Summary Chart for Change Order #1

Project:		Town Branch Thickening Process Upgrades Lexington, Kentucky Contract # 305-2018		Key Ow = Owner Om = Omission A/E = Architect/Engineer C = Contractor						
		No.	Date	Brief Description	Price	Ow	A/E	C	Om	CO No.
1	3/26/2019	Centrifuge Control Panel Changes Control Panel to be relocated to existing concrete equipment pad and existing spare conduit to be utilized. Control Panel to be single NEMA 4x with AC unit. Changes to circuit sizing.		\$10,670.00		X				1
2	5/7/2019	Addition of three plug valves and one check valve Addition of check valve to the chopper pump in Primary Sludge Pump Station No. 2 and 3 plug valves in the Gravity Thickener Building.		\$9,538.00				X		1
3	5/22/2019	Changes to Primary Sludge PS MCC Changes to motor control center configurations to prevent paralleling of 2 sources. MCCs to be configured to allow replacement of 3 VFDs; one at a time.		\$43,924.00	X				X	1
4	10/21/2016	Gravity Thickener Tanks Handrail & Grating Credit Replacement of handrails & grating to be removed from contract. Handrails and grating to instead be power washed and loose or missing fasteners to be replaced.		-\$25,100.00				X		1

Re: Town Branc

M-03-101
 DATE: OCTOBER 2019
 SCALE: 3/8" = 1'-0"

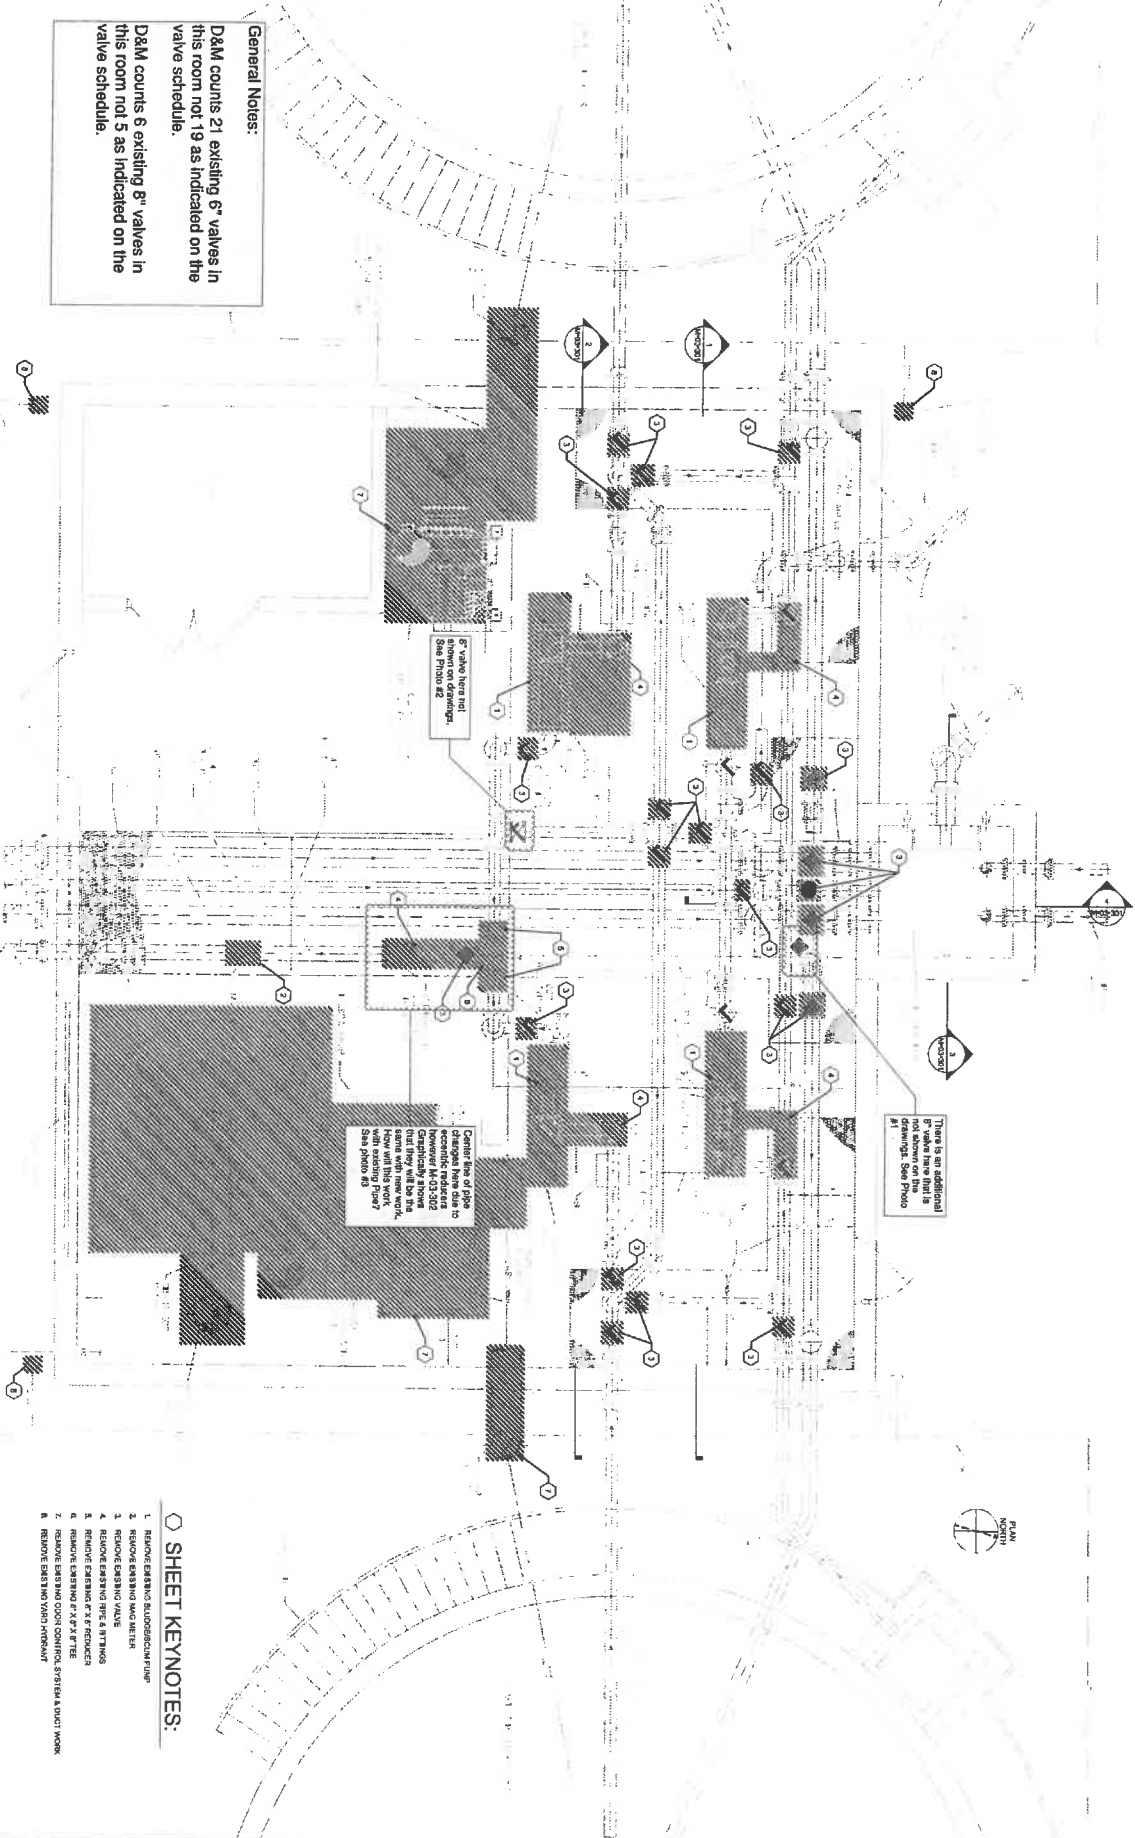
Section 4 on sheet M-03-301 indicates that the filtrate line coming out of the distribution box is a 10" line. Based on this section cut D&M became concerned regarding the size of two (2) valves in the Gravity Thickener Building which tie to this line but are labeled 8". During our 2/20/19 site visit D&M field measured the valves in place and confirmed that they are 8" valves as scheduled, however we noticed a few discrepancies from the drawings of which we were not previously aware, see attached markup of sheet M-03-101 and photos.

General Notes:
 D&M counts 21 existing 6" valves in this room not 19 as indicated on the valve schedule.
 D&M counts 6 existing 8" valves in this room not 5 as indicated on the valve schedule.

6" VALVE HERE NOT SHOWN AS PER PHOTO

Compare this to other drawings from date to electrical inducers however M&D 302 that they will be the same with new work with existing floor. See photo #1

There is an additional 6" valve here that is shown on drawing. See photo #1

1. The valves in section 4 on M-03-301 are 8".
2. There are 21 6" plug valves to be replaced in the Gravity Thickener Building. The attached drawing is correct.
3. There are 6 8" plug valves to be replaced in the Gravity Thickener Building. The attached drawing is correct.
4. Regarding the concern that the centerline of the pipe will be affected by replacement of the eccentric reducers at the tee in the Gravity Thickener Building, D&M previously requested a different piping arrangement at the tee which should align with the existing pipe. D&M requested to install a 8x8" true wye with reducers as opposed to the 8x6" reducing true wye called out in the plans. Use eccentric reducers to match the existing centerline.

JOB NAME:	town branch WWTP Thickening Process	EQUIPMENT DESIGNATION:	MCG-E2
JOB LOCATION:	421	EQUIPMENT TYPE:	MODEL 6 MOTOR CONTROL CENTER
DRAWN BY:	(D/C)	DRAWING TYPE:	ELEVATION
ENGINEER:		DATE:	May 21 2019
DRAWING STATUS:	QUOTE	DWG#	F11967520-01

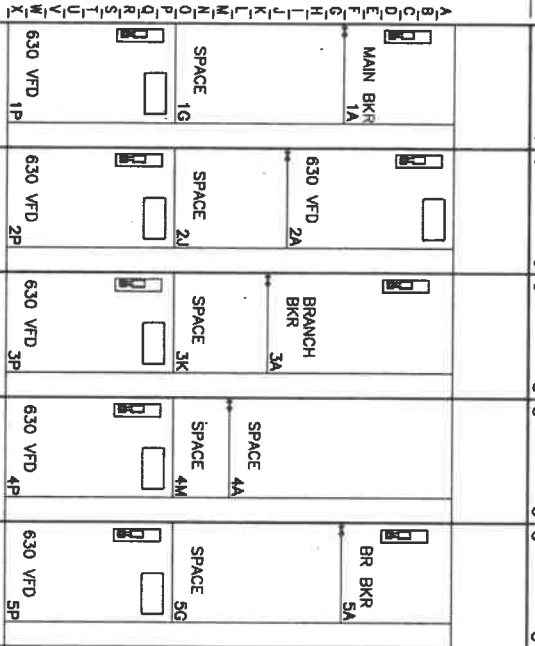
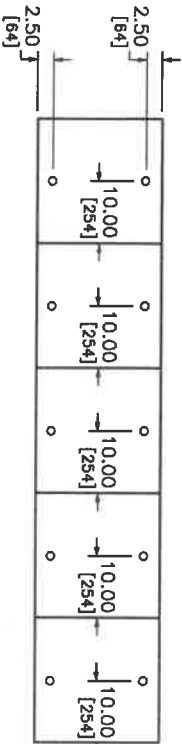
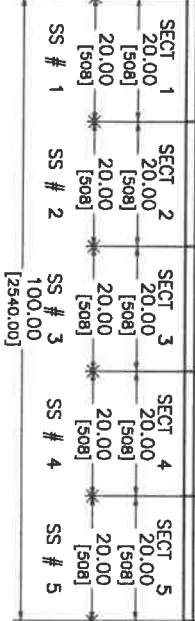
Description: C.O. #2 - Field Order #2 - Pricing includes TEM Group, Inc. furnishing and installing additional conduits, fittings, supports and wiring required for additional feeder conduits from existing MCC's to the two new MCC's per revised drawing E-00-603. Also included in pricing are the additional cost for revised Square D Motor Control Centers and two additional 200Amp Feeder Breakers added to the existing Eaton Motor Control Centers per the revised Field Order #2 Drawings dated 04/25/19.

**GRAVITY THICKENERS TANK PLAN & SECTION
NEW EQUIPMENT**

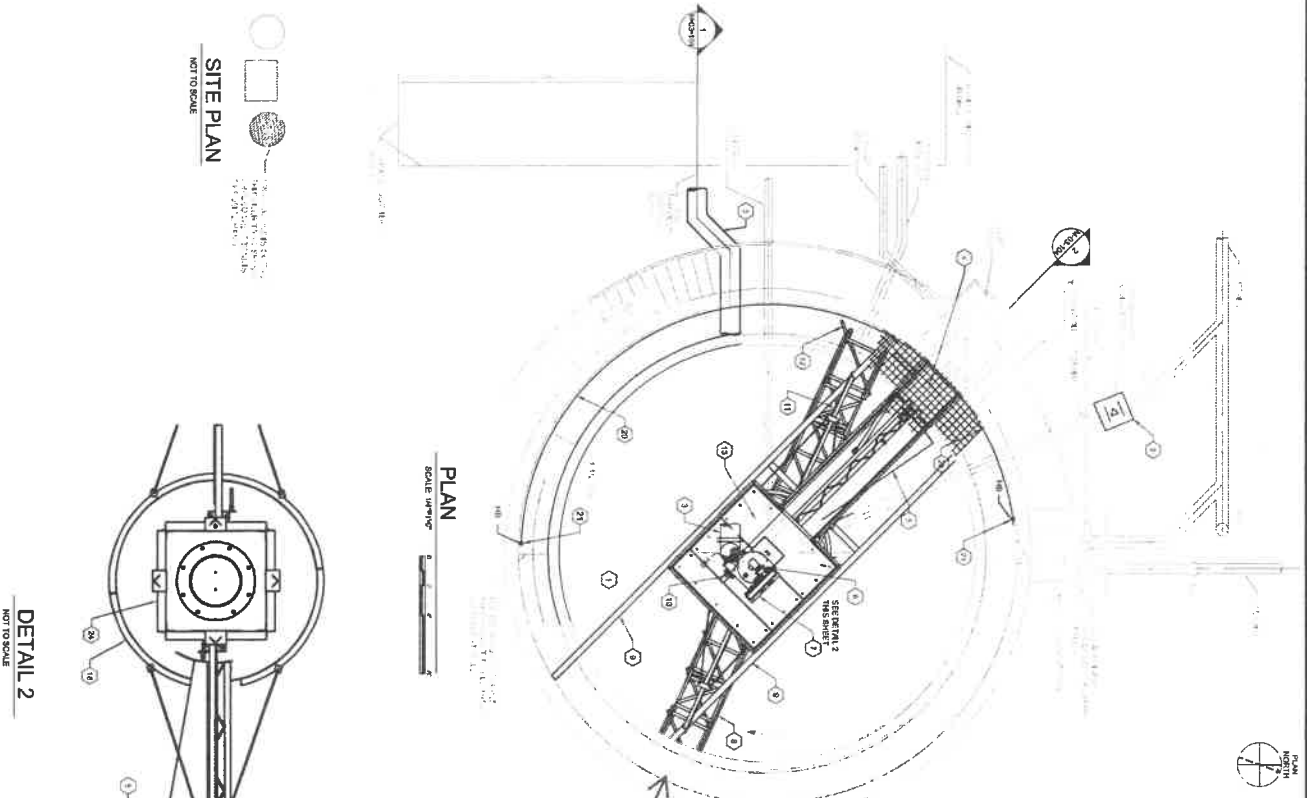
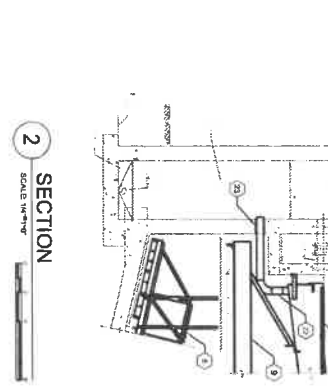
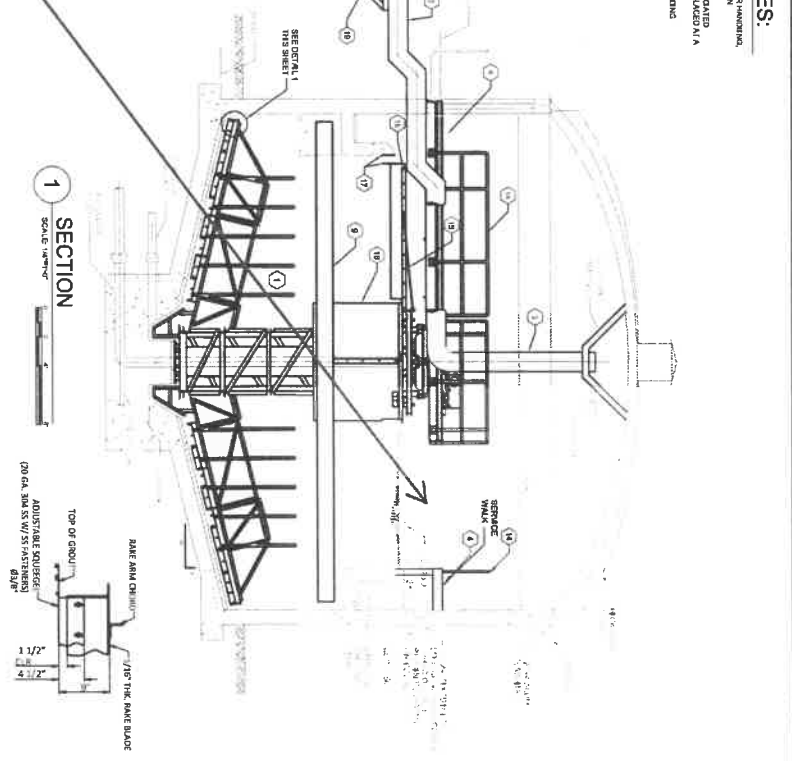
In follow up to onsite discussions with LFUCG on 5/2/19, Dugan & Meyers proposes to remove the handrail & grating at the (2) two Thickener Tanks from the scope-of-work for the lump sum credit amount of <\$25,100.00>.

This proposal includes changes only to the extent detailed in the attached mark-up of M-03-104. D&M will power-wash the existing handrail and grating in-place and check the mounting anchors & fasteners of these systems and make corrections as necessary.

Existing Handrail and Grating to Remain. Both Tanks. New Handrail and Grating will be provided on the new Vendor furnished bridge.
